# United States Patent and Trademark Office

PPLICATION NO.	FII	LING DATE	FIRST NAMED INVENTOR	ATTORNEY DOCKET NO.	CONFIRMATION NO	
10/628,848	0	7/28/2003	Victor J. Ortega	25040.0918	5200	
29052	7590	09/08/2006		EXAMINER		
		BILL & BRENNA	BELT, SAMUEL E			
	ACHTREE STREET, N.E. VTA, GA 30309			ART UNIT	PAPER NUMBER	
				3746		
				DATE MAILED: 09/08/2006

Application No.	Applicant(s)					
	10/628,848	ORTEGA ET AL.					
Office Action Summary	Examiner	Art Unit					
	Samuel E. Belt	3746					
The MAILING DATE of this communication appears on the cover sheet with the correspondence address							
Period for Reply							
A SHORTENED STATUTORY PERIOD FOR REPLY IS SET TO EXPIRE 3 MONTH(S) OR THIRTY (30) DAYS, WHICHEVER IS LONGER, FROM THE MAILING DATE OF THIS COMMUNICATION.  - Extensions of time may be available under the provisions of 37 CFR 1.136(a). In no event, however, may a reply be timely filed after SIX (6) MONTHS from the mailing date of this communication.  - If NO period for reply is specified above, the maximum statutory period will apply and will expire SIX (6) MONTHS from the mailing date of this communication.  - Failure to reply within the set or extended period for reply w

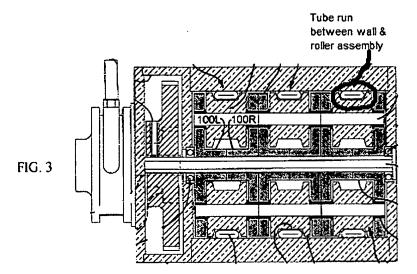
Wells et al. disclose a peristaltic pump for transporting a fluid within a flexible tube having a first end, a middle portion, and a second end, comprising: a roller assembly (Figure 2, item 110) positioned for rotation; a first door (Figure 2, item 82) positioned adjacent to said roller assembly and pivotable about a first direction; and a second door (Figure 2, item 84) positioned adjacent to said roller assembly and pivotable about a second direction; such that said first door and said second door may pivot open and said middle portion of said flexible tube may be positioned about said roller assembly; further comprising a base (Figure 3, items 86, 88, 90) such that said roller assembly may be positioned therein and such that said first door and said second door may be pivotably attached thereto; wherein said base comprises a tube inlet (Figure 2, item 118) and a tube outlet (Not labeled; However, clearly seen in Figure 2) positioned thereon; wherein said base comprises an indent (See Note 1) for said roller assembly to be positioned therein; wherein said base comprises a plurality of base

hinges (Figure 2, item 92) for pivoting said first door and said second door; wherein said first door comprises a wall, said wall positioned adjacent to said roller assembly so as to define a tube run therein (Not labeled; However, clearly seen in Figure 3, **See**Note 2); wherein said second door comprises a tube guide positioned thereon (Figure 2, item 112); further comprising locking means (Figure 2, item 94) positioned thereon for said first door and said second door; wherein said roller assembly comprises a plurality of rollers (Figure 2, item 106); wherein said roller assembly comprises a plurality of discs (Figure 3, items 100L & 100R)so as to mount said plurality of rollers thereon; wherein said plurality of discs comprises a plurality of roller mounting locations (Figure 3, items 108) such that the number of rollers may be modified; wherein said roller assembly comprises a plurality of replaceable rollers (**See Note 3**); further comprising a pump motor (Figure 3, items 128) in communication with said roller assembly; wherein said pump motor comprises a variable speed motor (column 8, line 49+); wherein said base, said first door, and/or said second door comprise acetal resin (column 7, line 43+)

- 1.) The bearings (Figure 3, item 96) of the roller assembly are received into base parts 88 & 90 via an indentation.
- 2.) Refer to the figure below.
